**U.S. Army Corps  
of Engineers**  
Engineering and Support  
Center, Huntsville

## **4<sup>th</sup> IBCT Physical Fitness Facility**

**Building 8437  
Fort Stewart, GA**

**POTR – Phase 1  
Project No 71152**

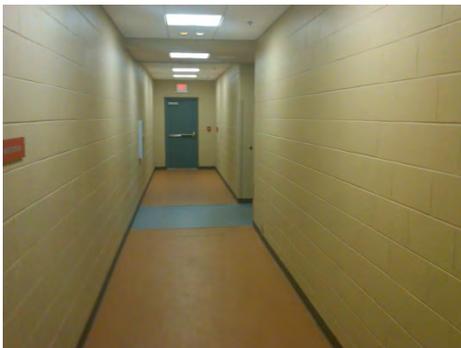
- The facility is provided with individual shower stalls with full-height ceramic tile walls. There is not really a separate drying stall (there is no separating curtain), but the shower stall is long enough to provide a drying area. The flooring is ceramic tile, and the ceiling is plaster. Originally, the floor in the shower room was not draining, so they had to come back and put a trench drain down the middle of the floor. The shower heads are on the sides of the stalls, which is preferred.

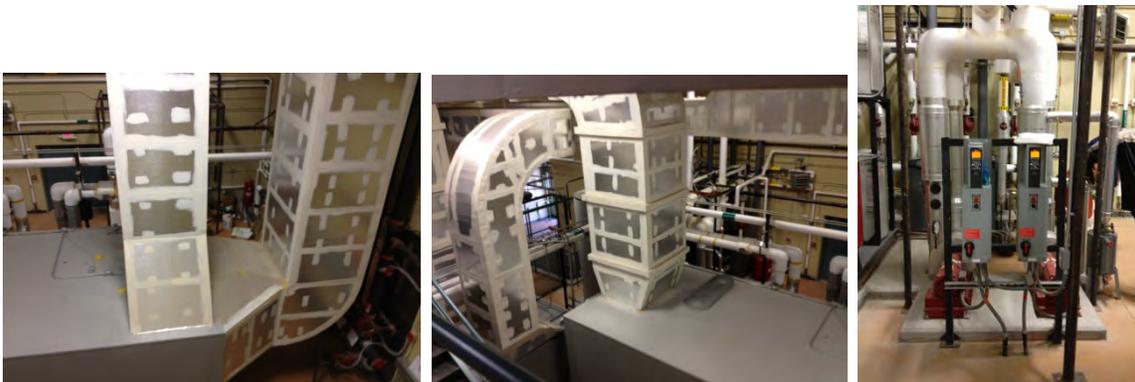
- The facility engineers and maintenance personnel indicated that a second unit to control the environment in the pool area had to be installed which differed from the RFP.
- The facility engineers indicated that there was a pressure issue in the pool area that has now been corrected. Initially, the pool area was not sealed properly and was allowing the chlorine gas from the pool area to leach into other areas of the facility. The engineers indicated that the problem was overlooked by the contractor's design. No other issues with pressure in the facility were reported.

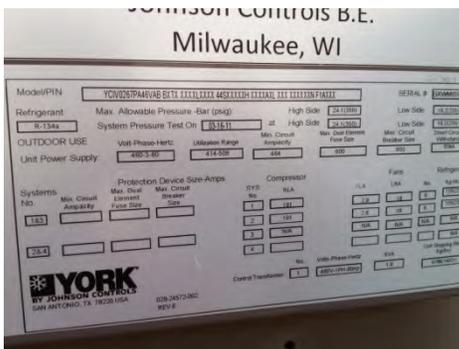
- The mechanical room for the facility seemed to be of an adequate size. One issue that was noticed

was that it is going to be very difficult to change the light bulbs out in the mechanical room. The fixtures are set high in the area and mechanical equipment was placed directly under the fixtures. If the need arises to change out the bulbs, a man lift or ladders cannot be utilized due to the location of the equipment and space constraints. However, the facility engineers and maintenance personnel had no complaints with the spaces allocated with the mechanical room or the pump control room.

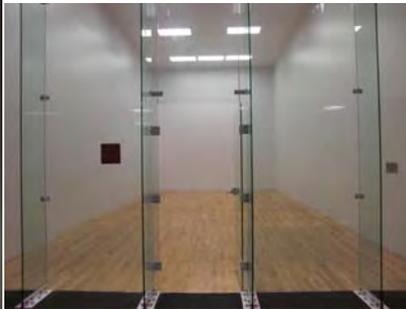
- Document satisfaction with intercom system (announcements understandable). The intercom is not operational. There is no sound from the speakers in the gymnasium.
